ENCLOSURE 2

CHANGES TO LICENSE APPLICATION CHAPTER 1

TRISO-X Fuel Fabrication Facility

Revision	: 2
Status	: Approved
Project	: Fuel
NRC Docket No.	: 70-7027

Figure 1-3: Plan View of Geologic Cross Sections

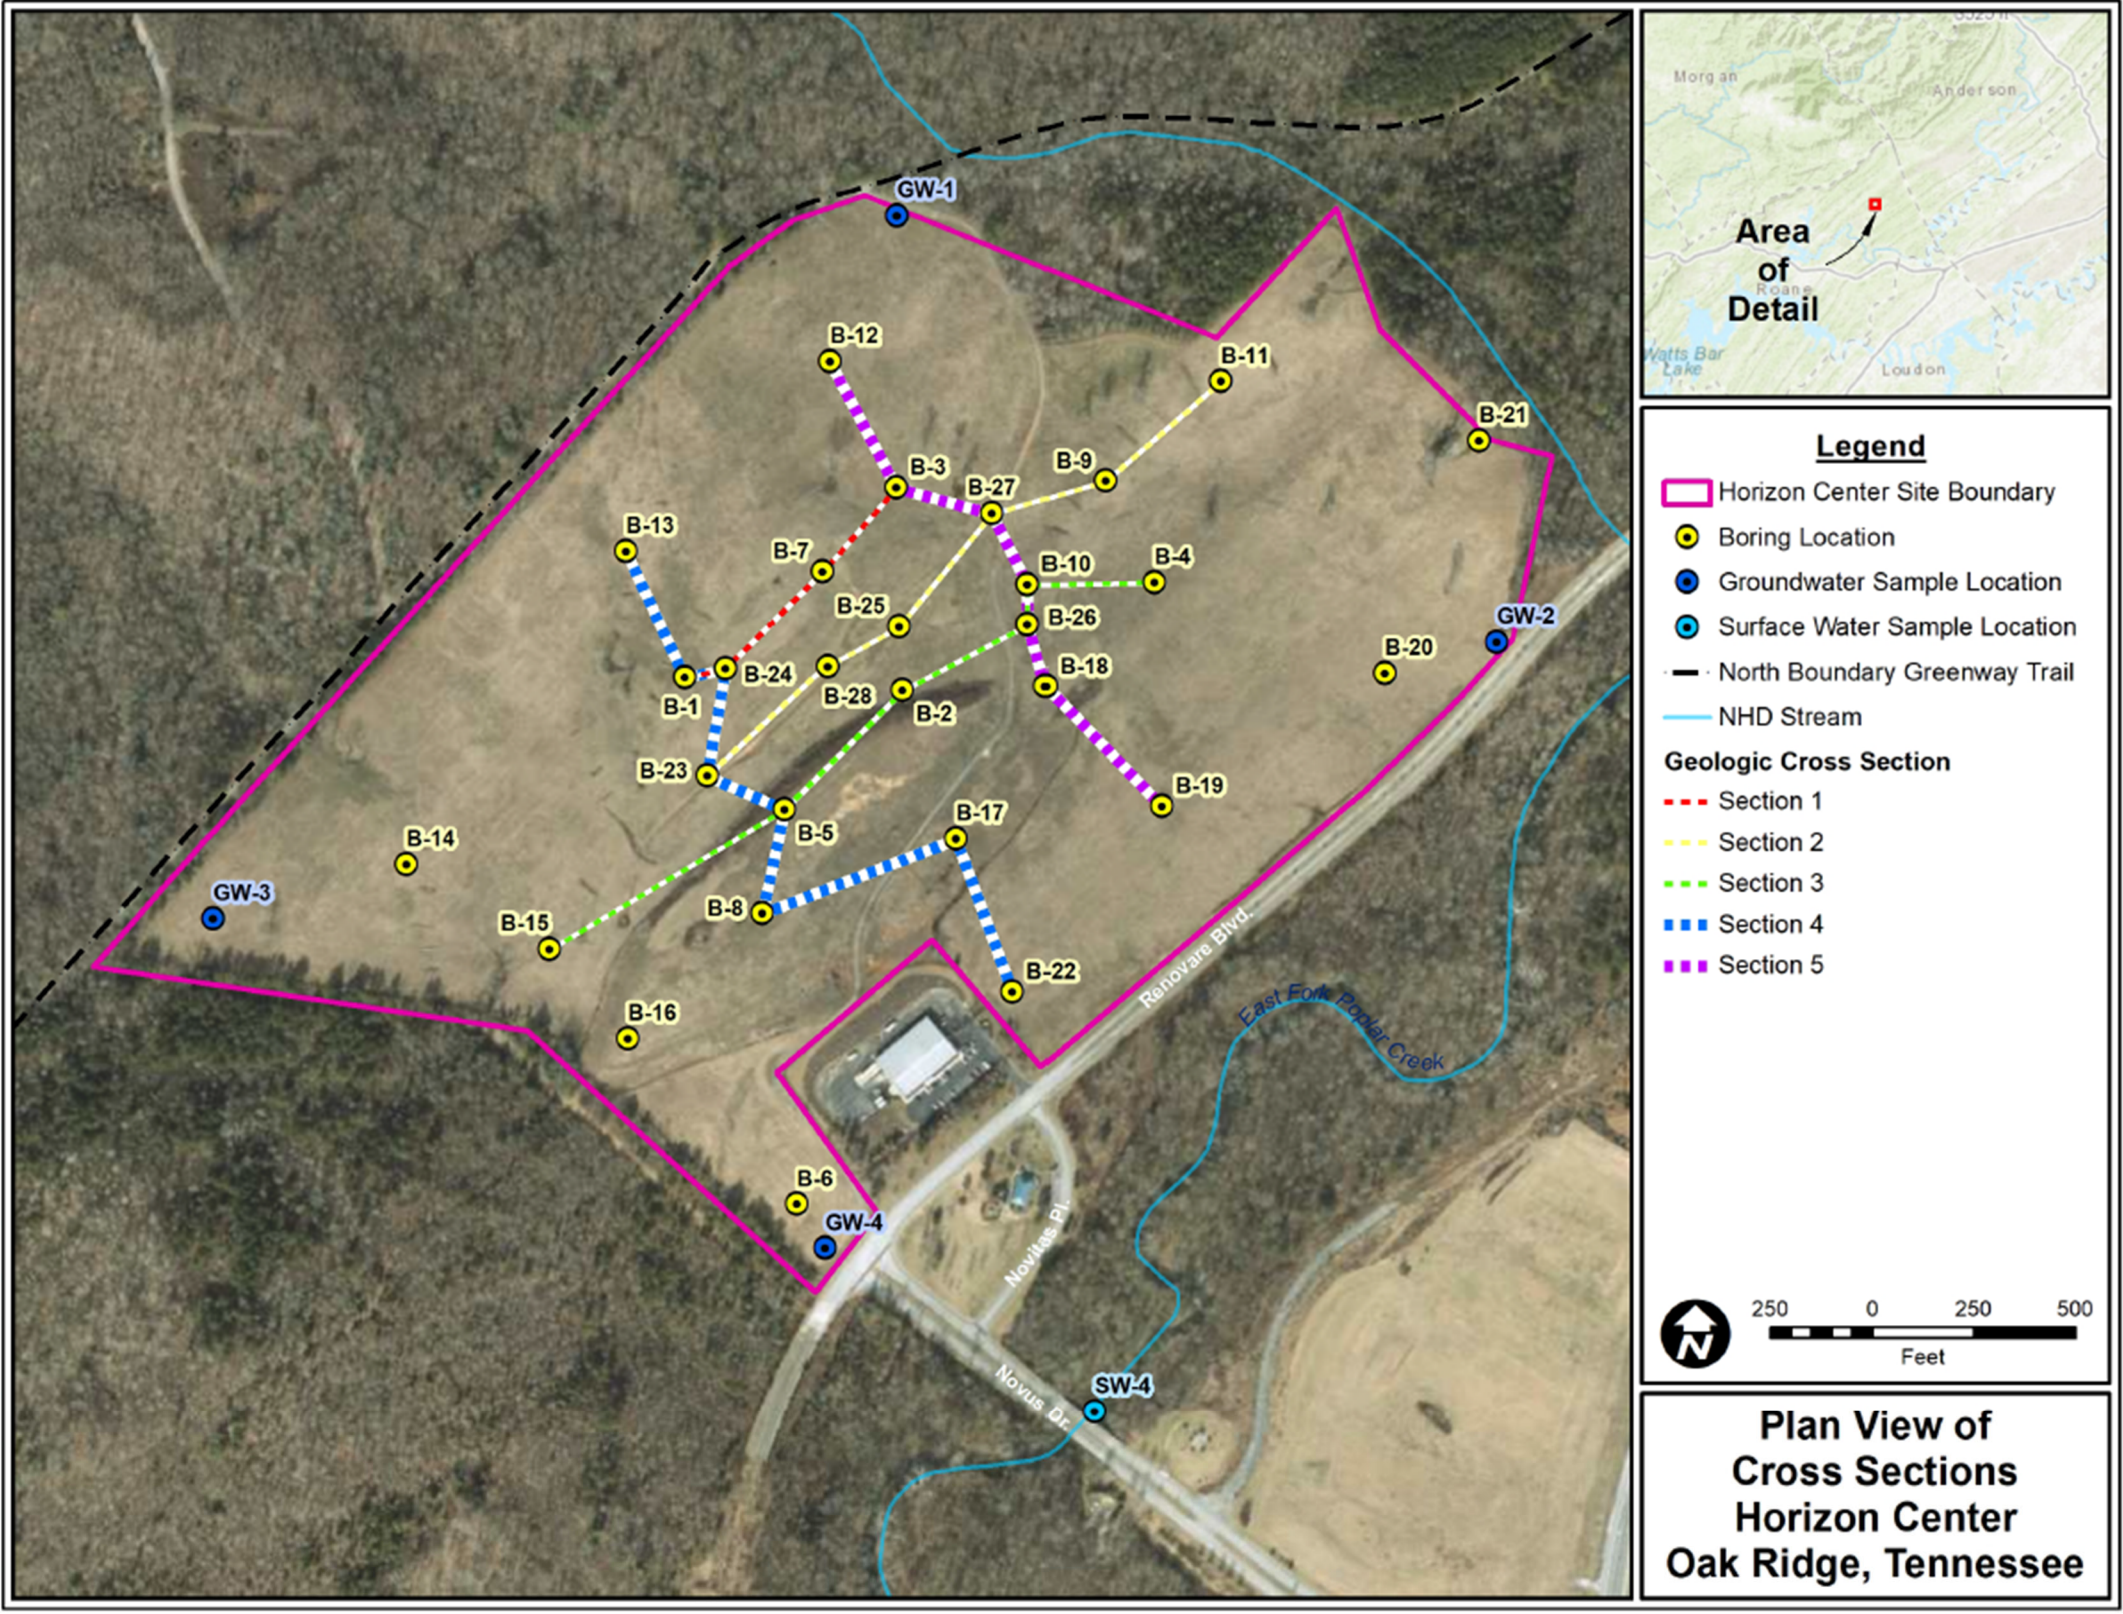
Revision	Date	Section/Page	Description of Change
1	5-Apr-22	ALL	Initial issue.
2	4-Nov-22	N/A	All changes for this revision are based on RSI responses (ML22286A144).
		Section 1.1.1	Added geotechnical discussion of site regarding slope stability, soil liquefaction, differential settlement, bearing capacity, karst features, and site cross sections.
		Section 1.1.2	Added design basis values for seismic, wind, precipitation, hydrological, and geological NPH.
		Section 1.3	Separated special exemptions and special authorizations. Re-numbered subsections.
		Section 1.3.1.1	Added detail for criticality monitoring exemption.
		Figures 1-3 thru 1-8	Added new figures for site geological cross sections.

The cross sections of subsurface soil/rock profiles are provided in Figures 1-3 through 1-8.
